Bolymin, Inc.

Engineer Change Request

Attention:	All customers	ECR No.:	ECR-0000067
Title and Content:	Relayout the FPC of BL160128A series	Issuing Date:	2014/11/18
Related Product:	BL160128A series	Engineer Change Execution Date:	
Reason of ECR:	☐ Request by customer ☒ Quality improvement ☐ Cost reduction ☐ Design improvement ☐ Productivity improvement ☐ Materials EOL	Customer Evaluation [] Approval [] Conditional Approval [] Reject	
Detail of the Change:	In order to improve the efficiency of DC/DC, we will relayout FPC of BL160128A series. Unit Dimension Change: [] Yes. [V] No. Electronic Feature Change: [V] Yes. [] No.	Comments:	
Usage of Old Material:	We will use the old material first, and then use the new material.	New sample Request: [] Yes, _____ pcs [] No.	
Affection Scope and Further Explanation:	For quality improvement, please help us to execute this ECR as soon as possible.	Signature/Date:

FPC appearance

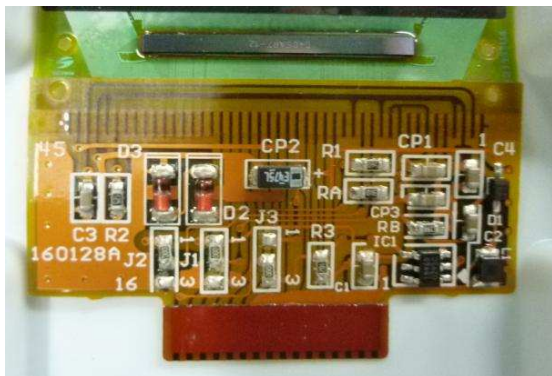
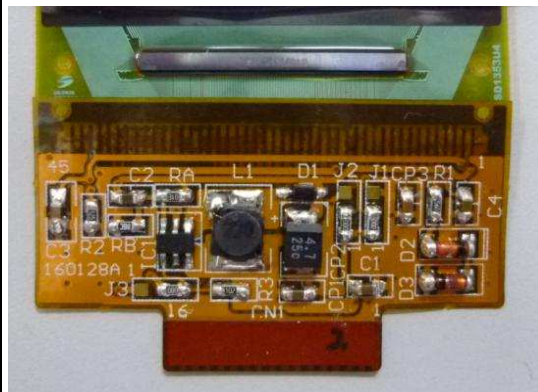
VDD=3.3V input
OLED:Brightness:60cd/m2 (min.),80cd/m2 (Typ.)
CIE:x:0.27~0.35 ;y:0.29~0.37 (White)
VDD (Full screen): 220mA,VCC~=14V
VDD (Screen off):20mA,VCC~=17.1V
voltage difference: 3.1V

VDD=3.3V input
OLED:Brightness:60cd/m2 (min.),80cd/m2 (Typ.)
CIE:x:0.27~0.35 ;y:0.29~0.37 (White)
VDD (Full screen):260mA,VCC~=16V
VDD (Screen off):20mA,VCC~=17.1V
voltage difference: 1.1V
